SUNDRY Do not use the	UNITED STATES EPARTMENT OF THE INTER BUREAU OF LAND MANAGEM NOTICES AND REPORTS his form for proposals to drill fell. Use form 3160-3 (APD) for	ON WELLS or to re-enter an	a: 10/1 4 /.	OMB N	APPROVED O. 1004-0137 anuary 31, 2018 or Tribe Name
SUBMIT IN	TRIPLICATE - Other instructi	ions on page 2		7. If Unit or CA/Agre	ement, Name and/or No.
Type of Well	ther			8. Well Name and No. BOROS FEDERA

Boros Federal 114H SUNDRY

PECOS DISTRICT DRILLING CONDITIONS OF APPROVAL

OPERATOR'S NAME: MATADOR PRODUCTION COMPANY
LEASE NO.: NMNM138865
WELL NAME & NO.: BOROS FEDERAL 114H
SURFACE HOLE FOOTAGE: 400'/N & 711'/E
BOTTOM HOLE FOOTAGE 100'/S & 990'/E
LOCATION: Section 15, T.26 S., R.31 E., NMPM
COUNTY: Eddy County, New Mexico

DETAIL VIEW SCALE: 1" = 100'

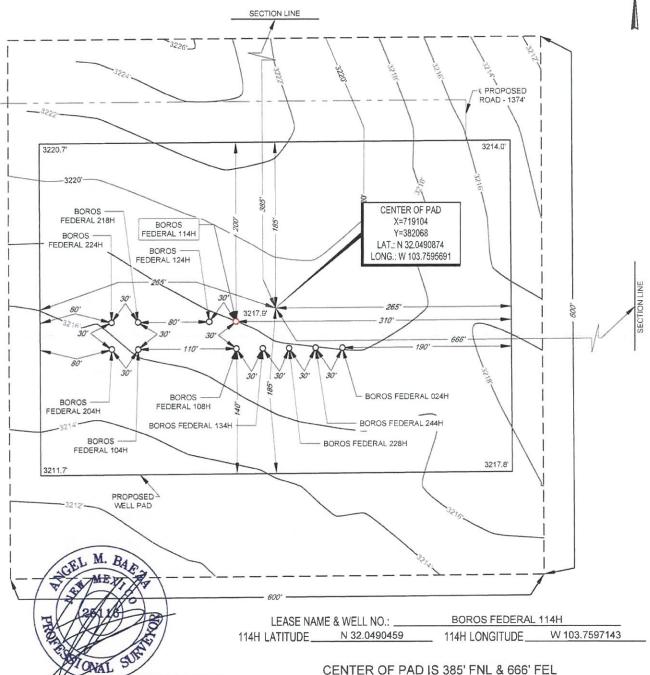
BLM Bond No. NMB001079 Surety Bond No. RLB001517	2				
from 430' FNL and 740' FEL of	2 to revise the SHL of Matador' of Sec. 15 T26S R31E to 400' F in the approved well pad locatio 020-2020-0098-EA.	NL and 711' FEL of Sec.	. 15 T26S F	31E. This I	10 40
Also, Matador respectfully rec	quests the option to amend the	casing, cementing and m	nud program	. Surface 9	pool same coms
Please find supporting docum BHermes@matadorresources	nentation attached and contact l	Blake Hermes at 972-37	1-5485 or	10-8-20	good Same coa's
APPROVED BY RA	LHEL IJABILEN	· REVIEW AT	POITION	MAL ENGU	YEERING COF
